**RESPONSE TO NRC QUESTIONS ON FORT CALHOUN'S
REFINED SEISMIC SPECTRA**

U.S. Nuclear Regulatory Commission

Omaha Public Power District

October 1990

Figure I.12 - Comparison of Response Spectra (Time History vs. USAR)
Vertical Direction, 5% Damping

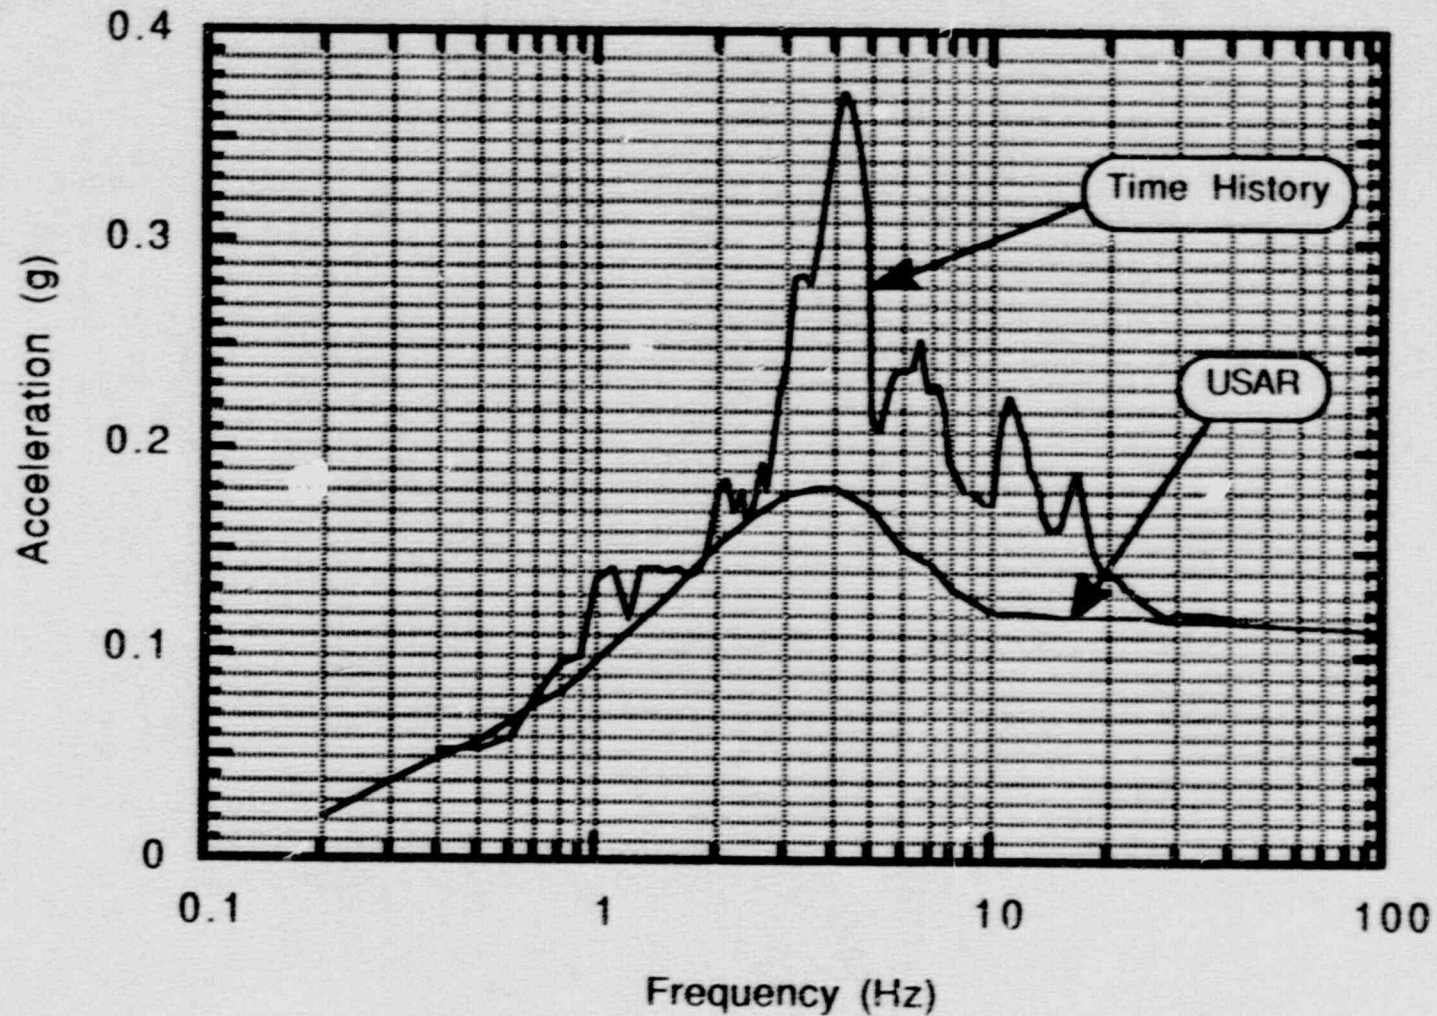
- (1) OI: (a) The Standard Review Plan (SRP) (NUREG-0800) recommends that the Power Spectral Density function (PSD) of an artificial time history used for single time history analysis meet a target PSD spectrum (NUREG/CR-3509).
- (b) The floor response spectra were calculated for a number of damping values ranging from 1 percent to 10 percent. To meet SRP requirements a check must be made that the response spectra of the artificial time history envelope the design response spectra for all damping values used in the response analysis.
- (c) The SRP recommends that the stationary phase strong motion duration of the artificial time history should be between 6 and 15 seconds.
- (2) RAI (a) Provide the information that the intent of the SRP recommendations are met.
- (b) Provide Impell's version of SIMQKE together with its user's manual.

- (b) Checks were made in Impell Calculation THG-1 to verify that the response spectra obtained from the three artificial time histories (NS, EW and vertical directions) envelop the USAR ground spectra. The spectra checks were performed for 2% and 5% damping, since the USAR design ground spectra are available only for 0, 0.5, 2 and 5% damping. The results from the checks are also included, in Figures 1.7 to 1.12, which show that ample margin above the design ground spectra exists for all directional time histories and damping values.

Figure V.1 - Reactor Building Foundation Geometry

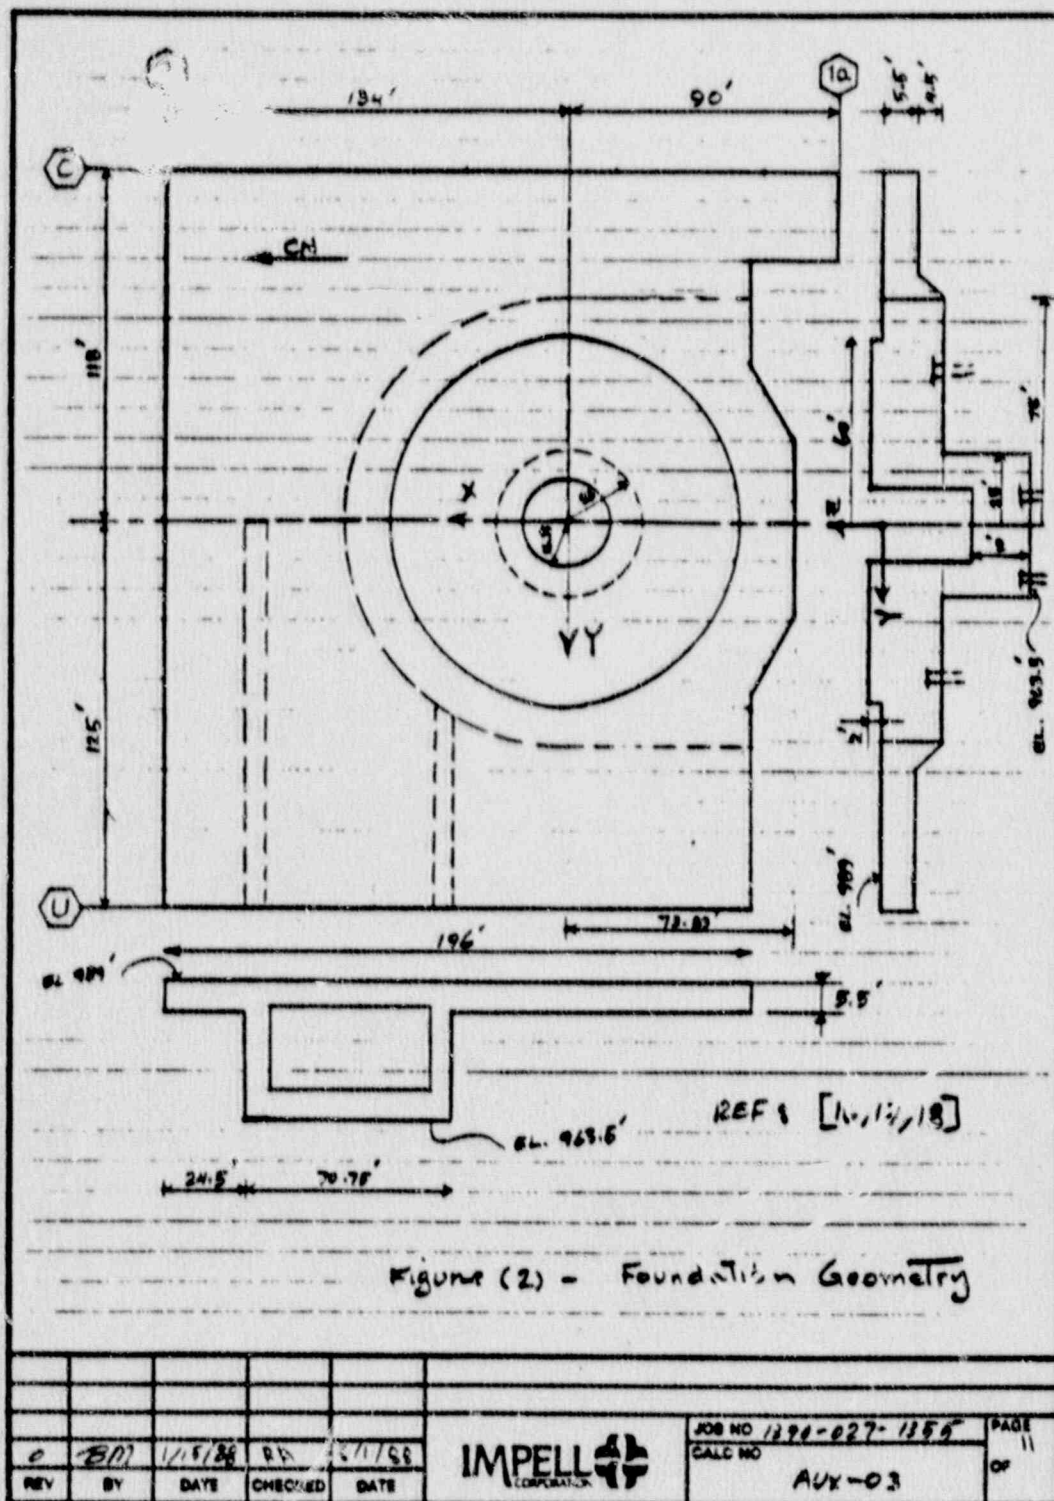
- Document: Impell Corp., "SSI Analysis and Design Spectra Generation for Auxiliary, Internal, and Containment Buildings", 9/26/88.
- (1) OI: (a) Assumption of rigid mat foundation. Selection of pile foundation impedances.
- (b) Impact of piles on ground motion soil column properties for best estimate (BE), upper bound (UB) and lower bound (LB) properties effect of building on soil properties.
- (2) RAI (a) Specify the properties of the BE, UB, and LB soil columns. Discuss and provide the necessary justification or verification for the items listed under open issues.

- (1) OI: (a) The foundation geometry of the Reactor Building is shown in Page 11 of Impell Calculation AUX-03 (also shown herein in Figure V.1). The area of the basemat that supports the Containment and the Internal Structure is 10 ft. thick. The remaining part of the basemat, which supports the Auxiliary Building, varies in thickness from 5.5 ft. to 10 ft., as shown in Figure V.2. In addition, as shown in Figure V.3, the Auxiliary Building at basemat elevation has numerous concrete walls which contribute significantly to the out-of-plane stiffness of the basemat. Furthermore, the 803 piles of the Reactor Building contribute to the overall stiffness of the foundation system in the out-of-plane direction of the basemat, because the piles are axially very stiff and are driven into bedrock.

Figure VII.1 - Schematic of the Soil Profiles Used in the Seismic Analyses

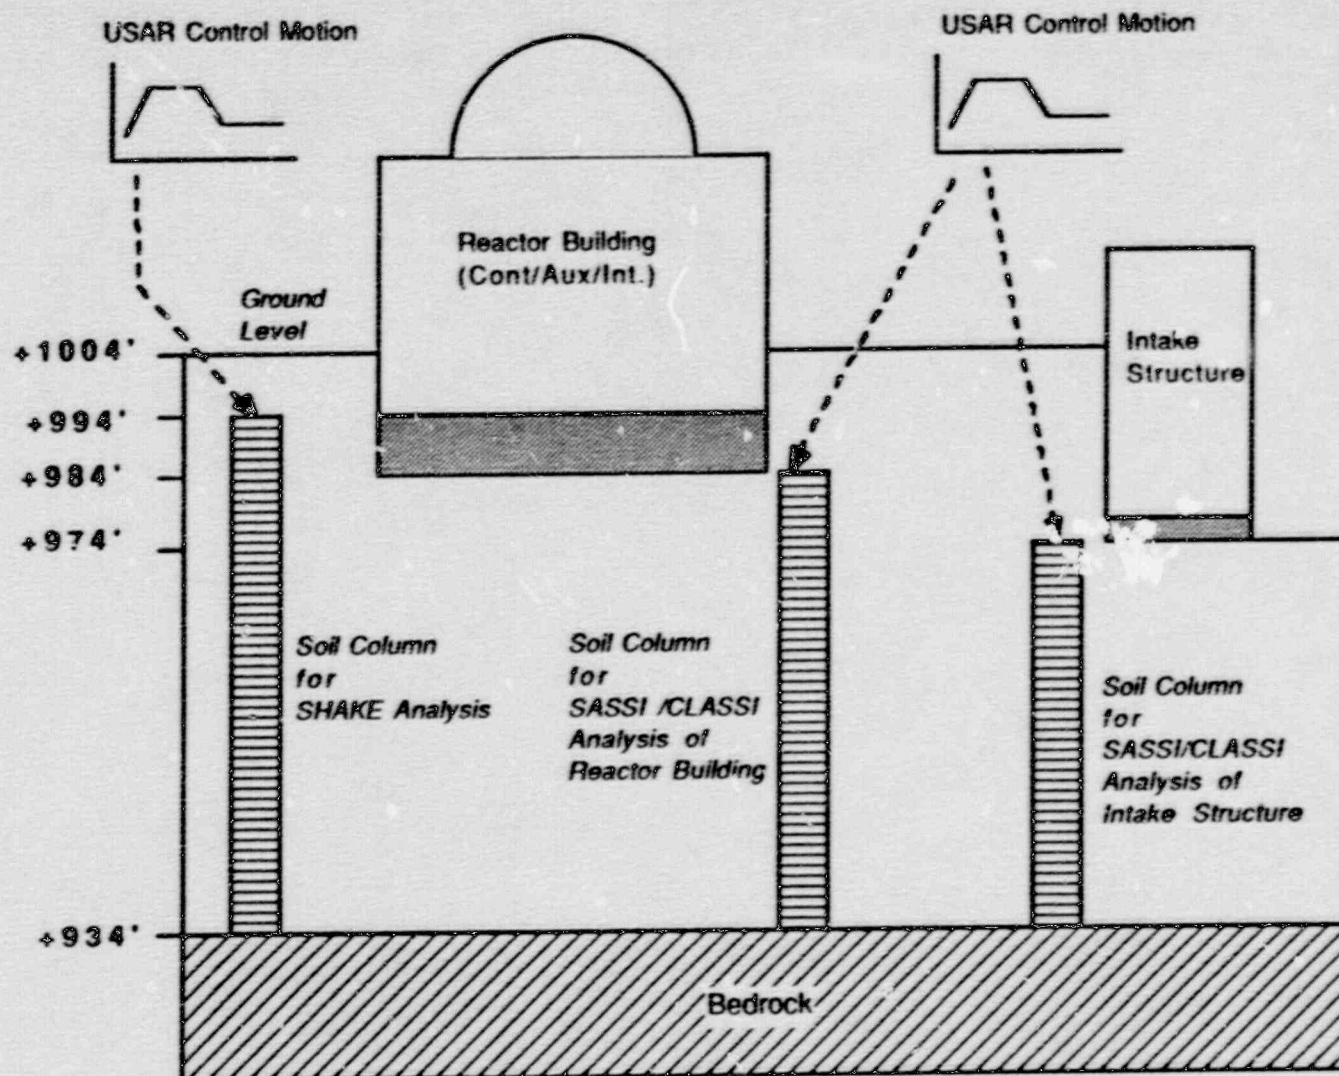
- (b) The Intake structure is not embedded on the side facing the Missouri River, its mat is 30 feet below ground surface elsewhere. Provide justification for the use of strain compatible soil properties generated by SHAKE for a soil profile extending from bedrock to ground surface.

- (1) OI:
 - (a) The SRP recommends that the input motion be applied at the top of competent material (elev. 934) or at an outcrop.
 - (b) The natural frequencies of the Intake Structure should be included in the foundation impedance calculation and subsequent SSI calculations.
 - (c) Upper and lower bound soil properties should be included in the SHAKE calculations.
- (2) RAI
 - (a) Provide Impell's versions of SHAKE theoretical basis and user's manual.
 - (b) Provide Impell's version of RANDOM theoretical basis and user's manual.
 - (c) Provide analyses which include a, b, and c conditions discussed under OI.

The properties of the soil layers between +934 ft. and +974 ft. are identical to the properties of the layers between +934 ft. and +974 ft. obtained from the SHAKE analysis. The soil profiles used in the SHAKE and the SASSI/CLASSI analyses are shown in the schematic of Figure VII.1.

- (1) OI:
 - (a) The seismic control motion is applied in the free field at elevation +974 ft., which corresponds to the level of the foundation basemat of the Intake Structure (refer to the schematic of Figure VII.1). This is conforming to SRP Revision 1 Section 3.7.1.1.4 recommendations, which were available during the duration of the alternate spectra development work.
 - (b) Refer to Question VII, OI(e) for justification on the foundation impedances and the frequencies used in the analysis.
 - (c) Similar to the response provided for Question V, OI(b), the generated response spectra at the Intake Structure were broadened by $\pm 15\%$. The $\pm 15\%$ broadening is consistent with the recommendations of SRP Revision 1 Section 3.7.2 (Reference 8), and Regulatory Guide 1.122 (Reference 9) for broadening spectra in the absence of parameter variation studies.

Figure X.1 - Variation of Soil Damping with Strain
(Fort Calhoun Data)

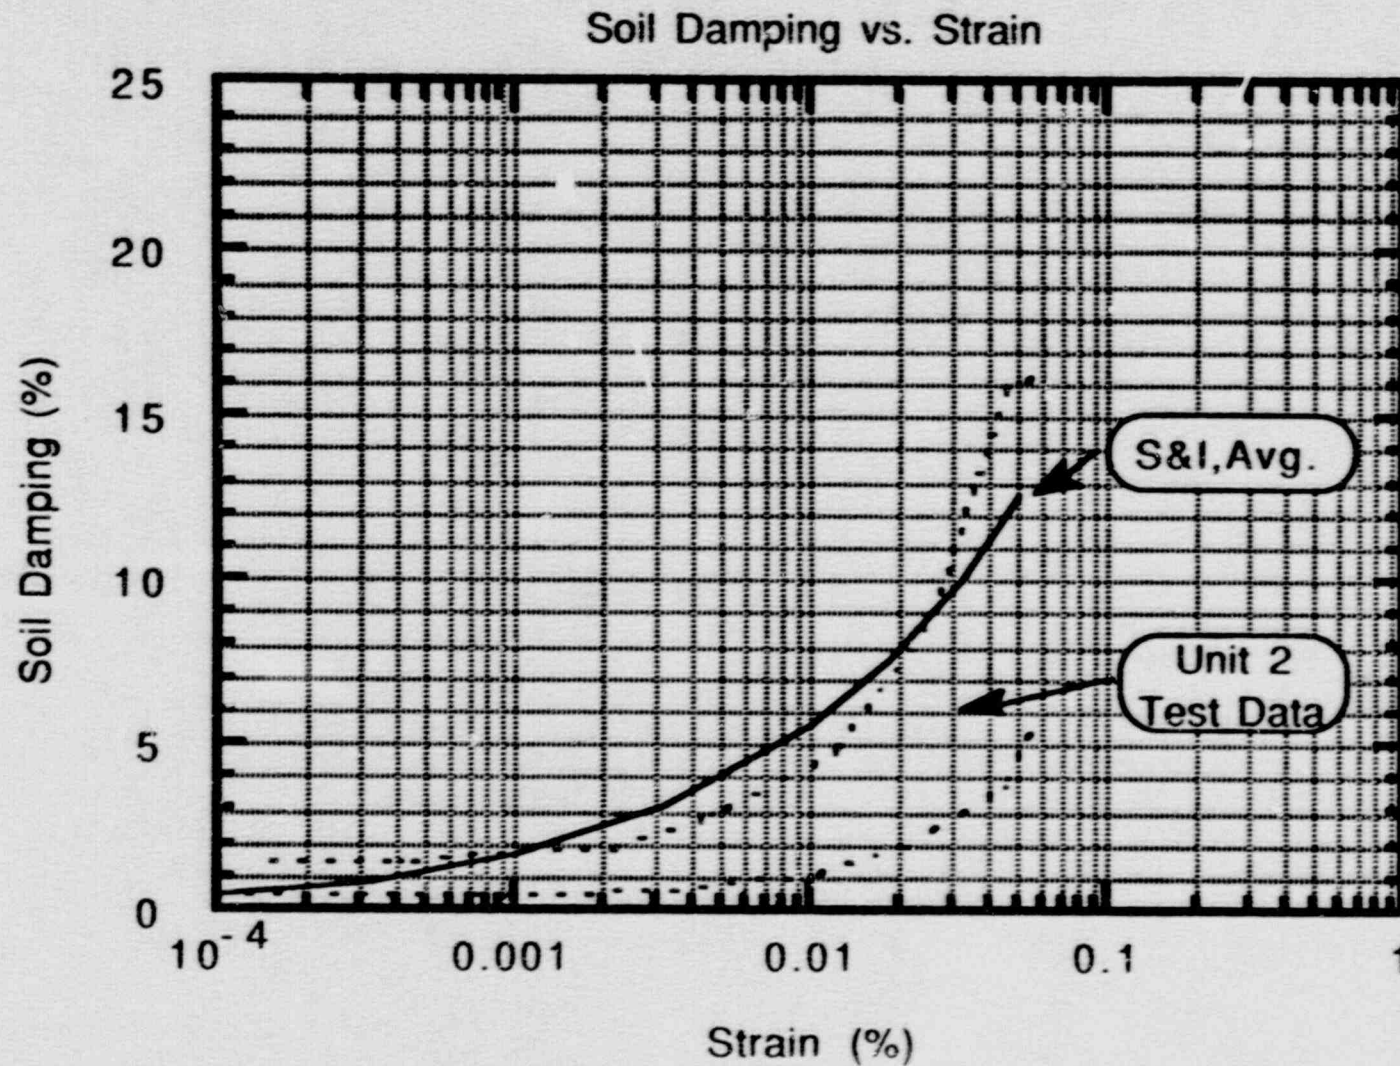
- (b) Strain-dependent shear moduli and damping degradation data provided by Seed for sand type materials were employed in the SHAKE analysis. A study to verify that the materials at the site correlate with those used for the data generated by Seed was not performed.

Geotechnical investigations performed at the Fort Calhoun site as part of the preliminary design of Ft. Calhoun Unit 2 (Reference 7; also included in Calc. No. SOIL-1) show that soil damping ratios from resonant column test data and cyclic triaxial test data are contained in the area shown between the dotted lines in Figure X.1. The average Seed and Idriss curve is nearly identical to the upper bound of these test data. Since energy dissipation due to frictional forces between the piles and the soil, and between the basemat and the soil are not accounted for in the SSI model, using the upper bound soil damping data are, by engineering judgement, more appropriate to represent realistic energy dissipation conditions at Ft. Calhoun during a seismic event. Furthermore, the use of the Seed and Idriss damping curve has been shown to give excellent results in experiment vs. analysis correlation studies of soil response of similar sites to Fort Calhoun (refer to the discussion in item (g) below). Therefore, the use of the Seed and Idriss average damping curve is adequately justified for the computation of strain-compatible soil properties.

The Lotung site is a soft soil site with sand material of shear wave velocities very similar to the Fort Calhoun soils. The laboratory tests result in soil material damping ratios in the range of the Fort Calhoun material damping ratios (Figure X.2, from Reference 7). In the Lotung SSI analyses, Impell utilized the damping curve shown in Figure X.2, which is very similar to the Seed and Idriss average damping curve. The strain-compatible damping ratios used by Impell in the SSI analysis of the May 20, 1986 and November 14, 1986 earthquakes are tabulated in Table X.1 (Reference 7). The horizontal peak ground accelerations (PGA) of the two Lotung earthquakes were 0.17g and 0.20 g, respectively, which are similar to the Ft. Calhoun PGA. The damping values used in the Lotung analysis are tabulated in Table X.1 (from Reference 7). The results of the correlation study between experimentally measured and analytically calculated seismic response show a nearly perfect match of the free-field motion at depth between analysis and experiment. Figure X.3 shows the response of the free-field soil (in the form of response spectra) at a depth of 6 meters (20 ft.) and 47 meters (154 ft.), respectively. These comparisons demonstrate the appropriateness of the use of soil material damping curves similar to the average Seed and Idriss curve for soft soil sites.
